**DOCUMENT 00 90 00  
ADDENDUM**

**ADDENDUM NO. [2]                      Date: January 5, 2022**

**RE:                      SCHOOL DISTRICT OF ABBOTSFORD  
ABBOTSFORD SCHOOL DISTRICT FEMA ADDITION  
510 WEST HEMLOCK STREET  
ABBOTSFORD, WISCONSIN 54405  
HSR PROJECT NO. 21027**

**P101**

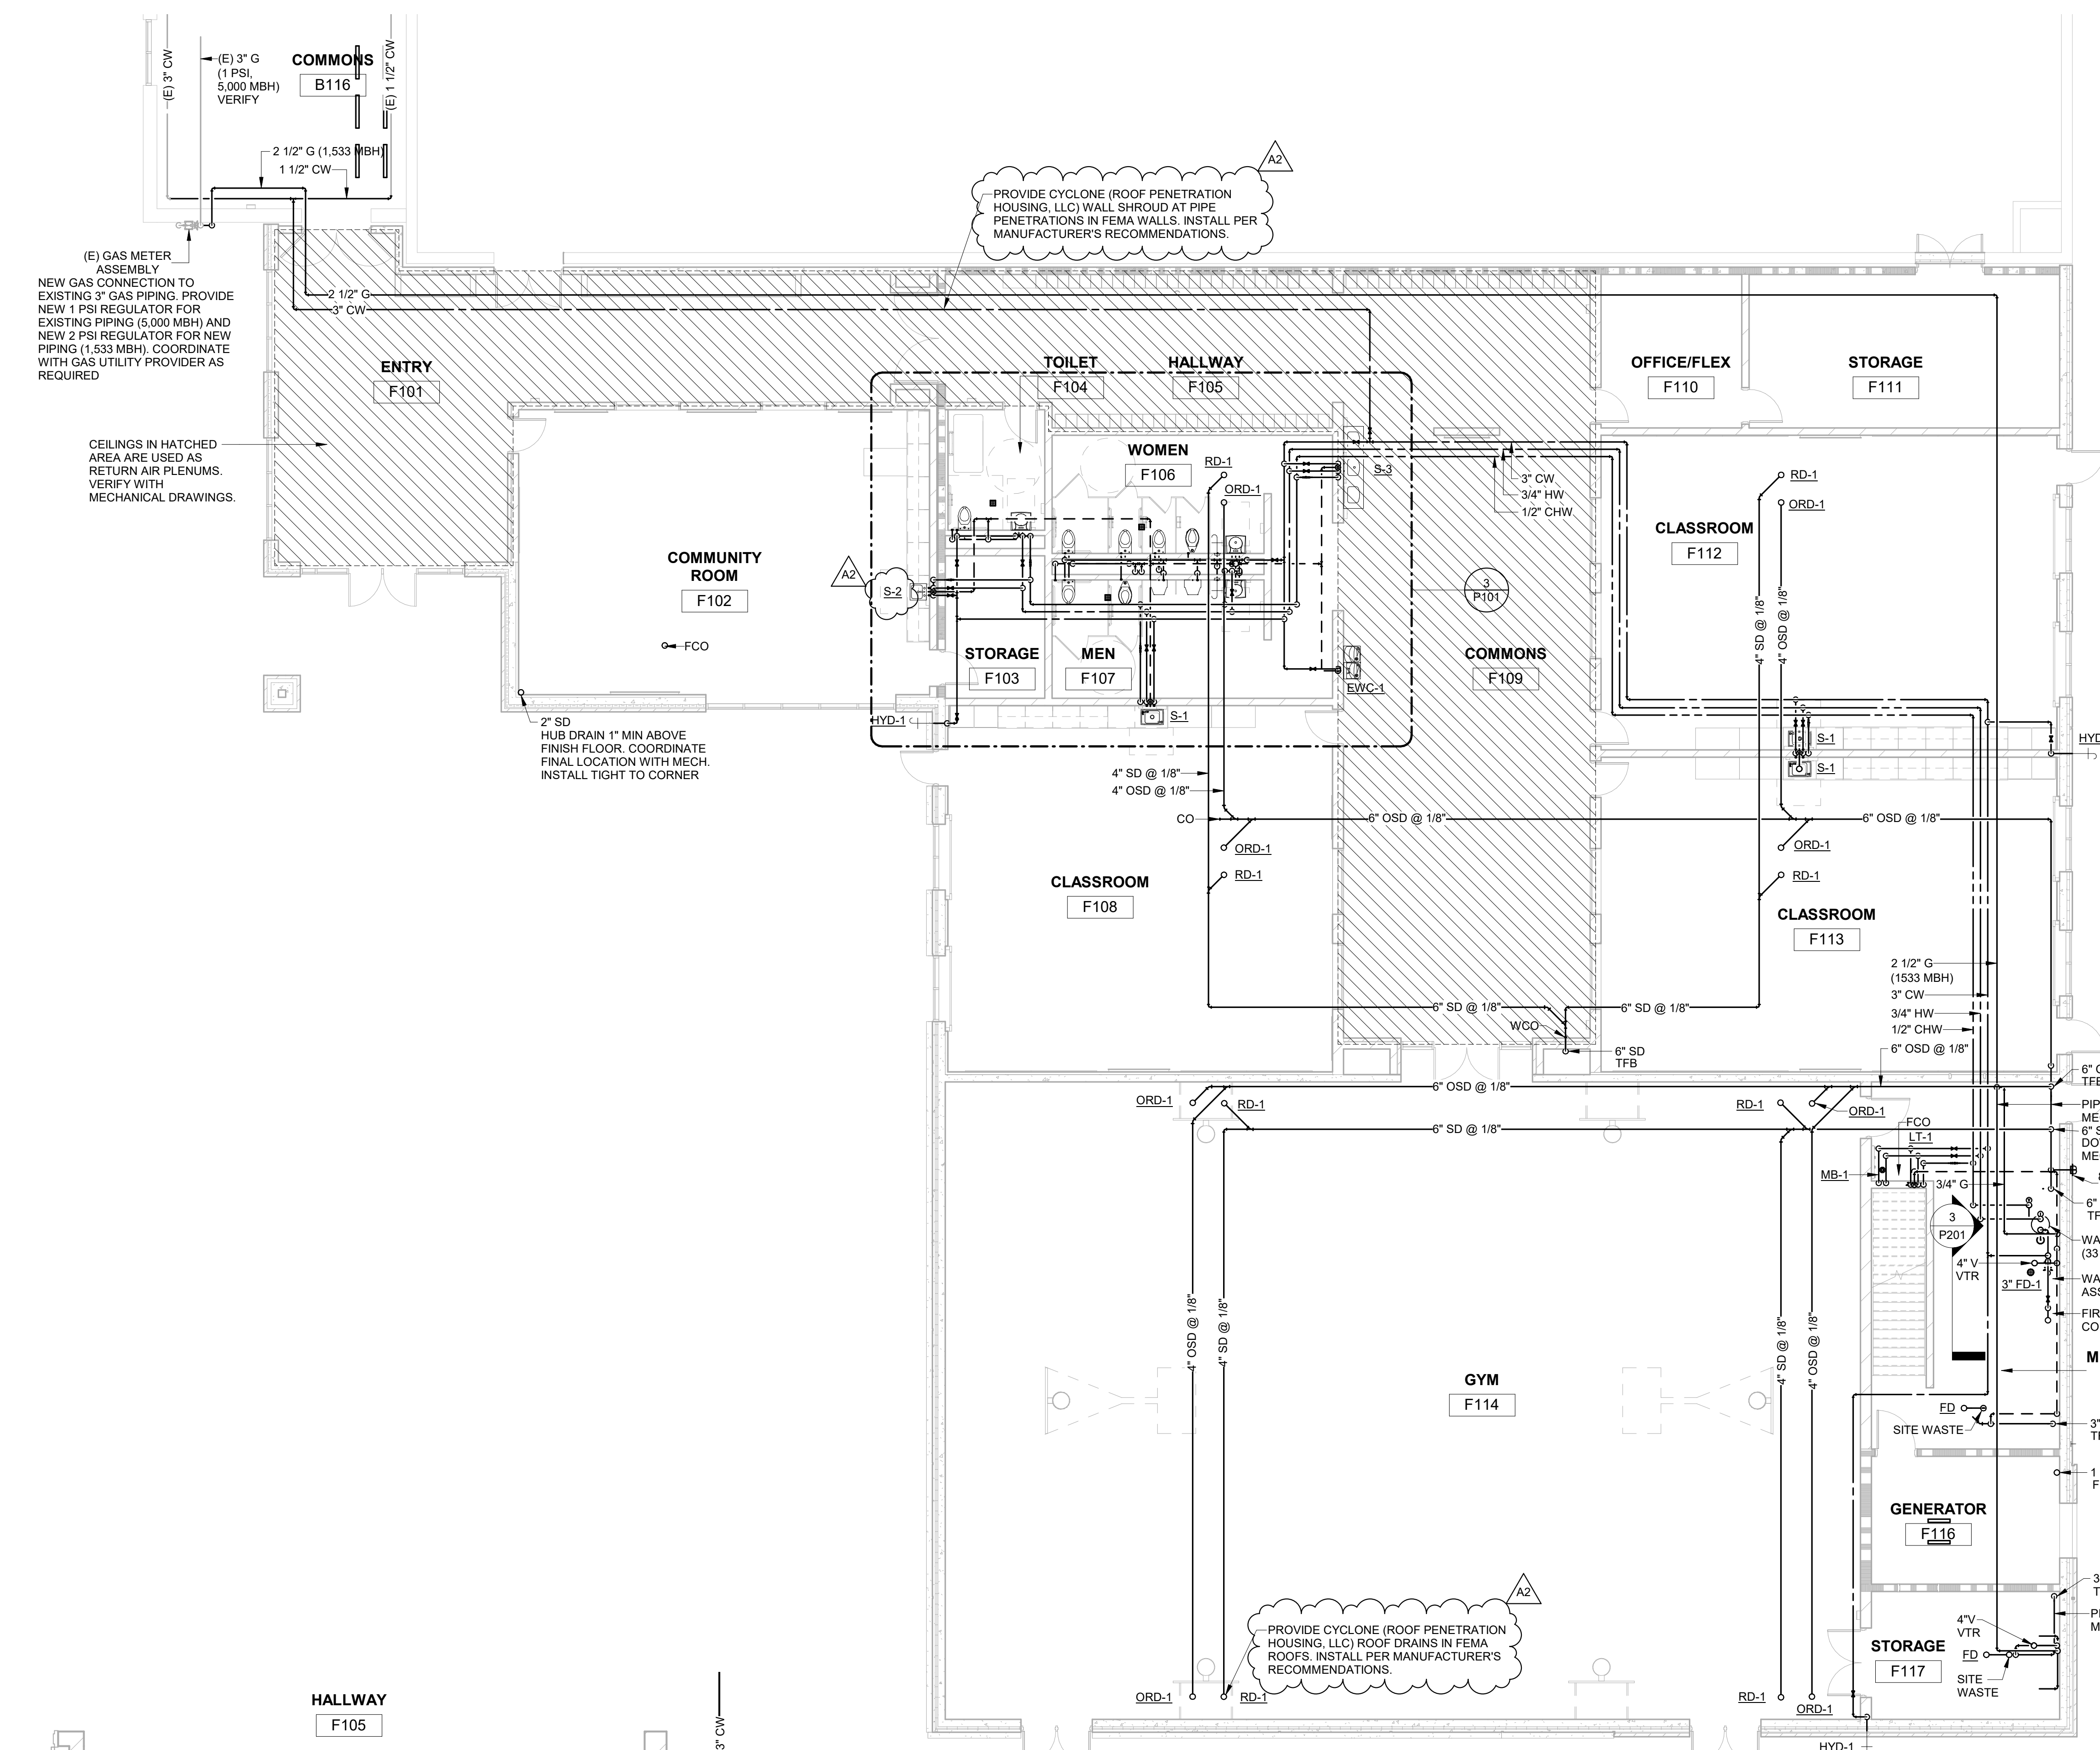
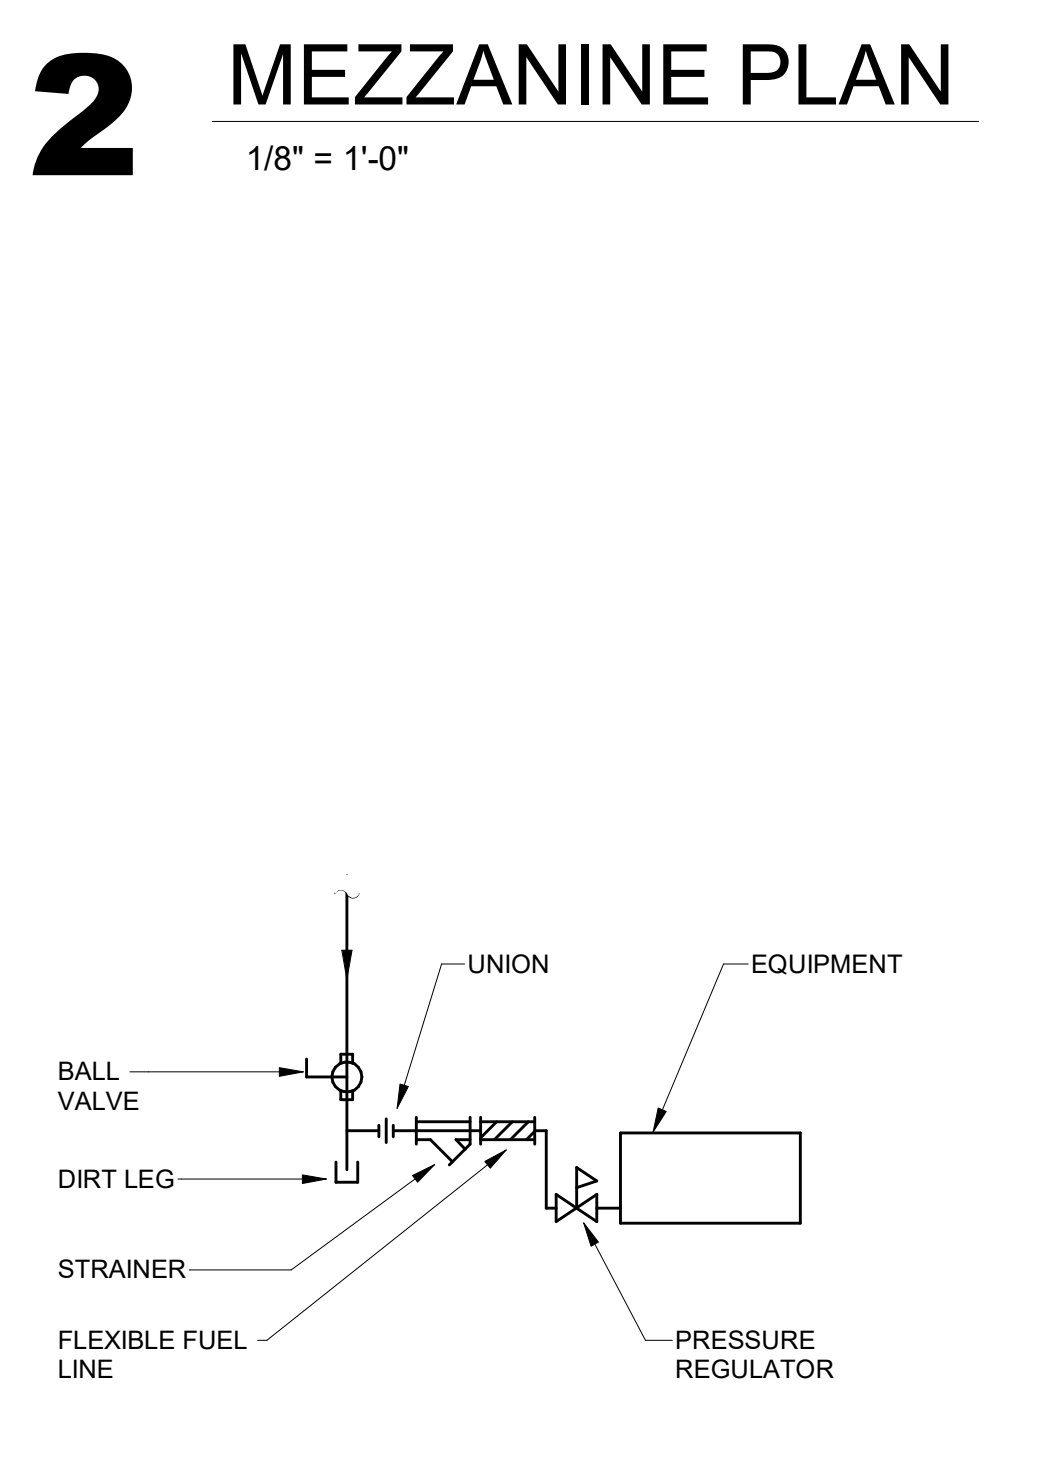
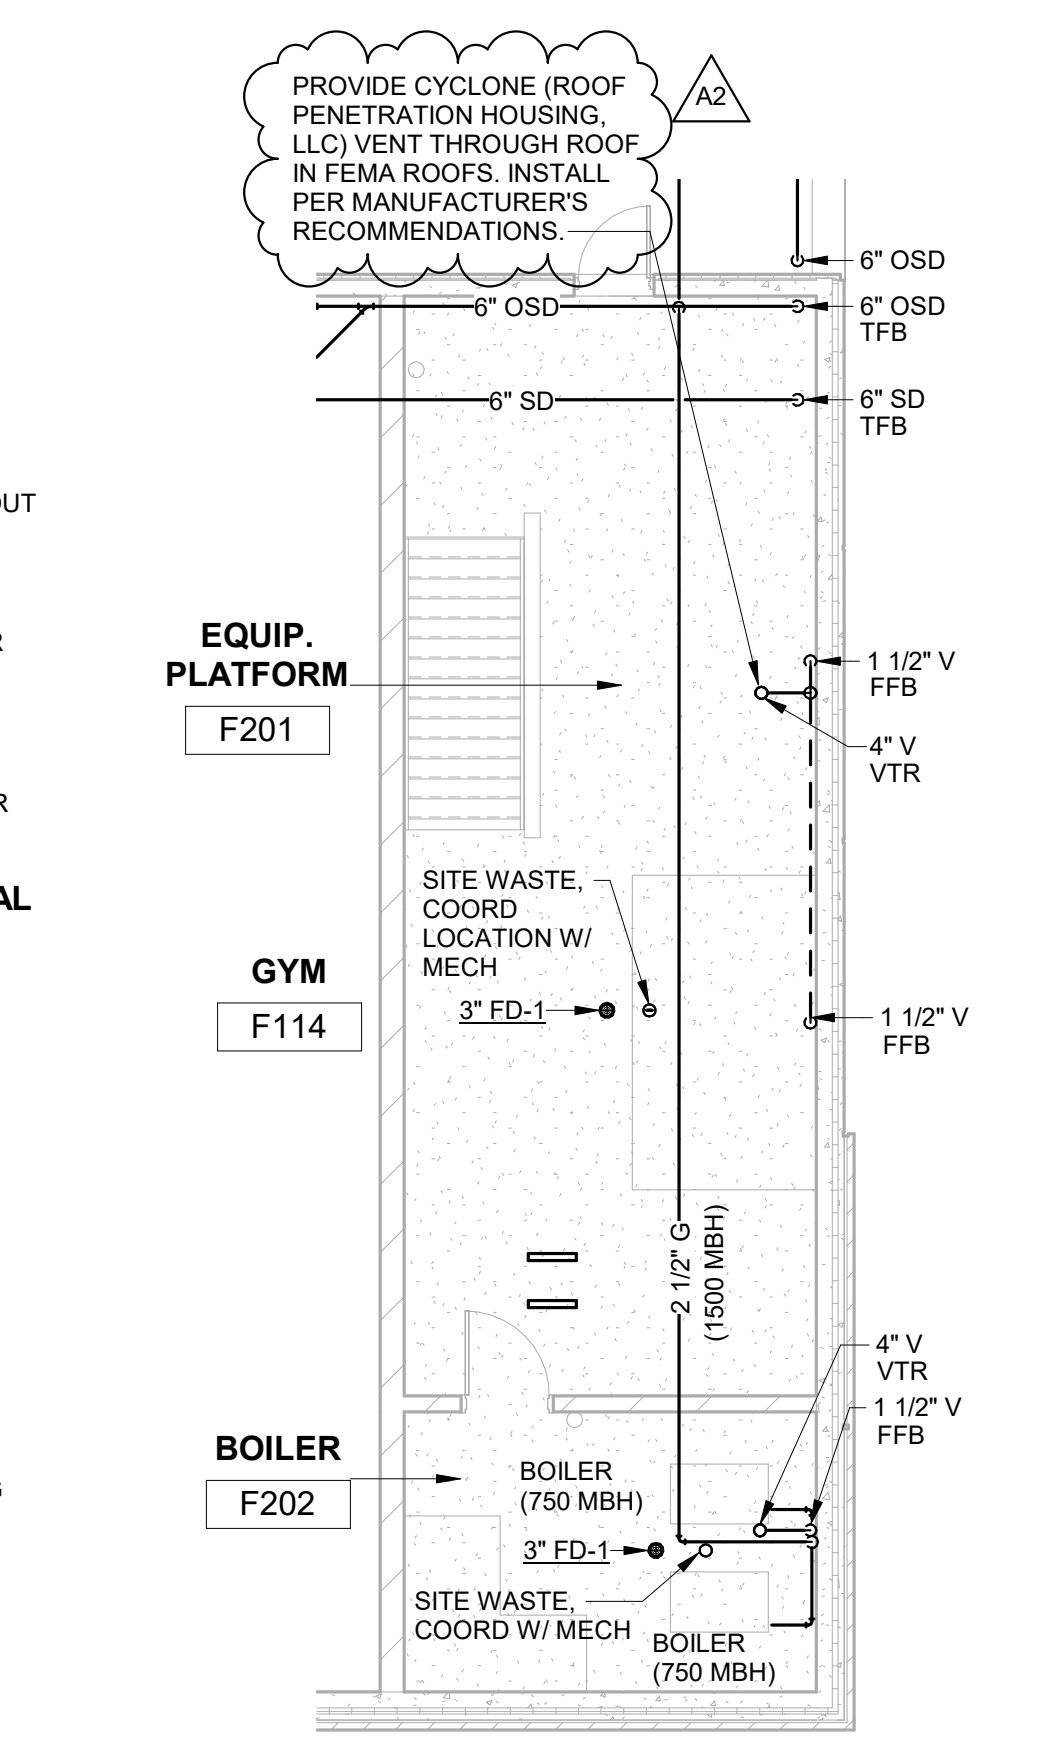
20. Sheet P101 FLOOR PLAN revised 30 x 42 sheet attached hereto.

- a. Revised sink designation from S-1 to S2.
- b. Added note regarding Cyclone roof penetrations.
- c. Added note regarding coordination with underground LP supplier.
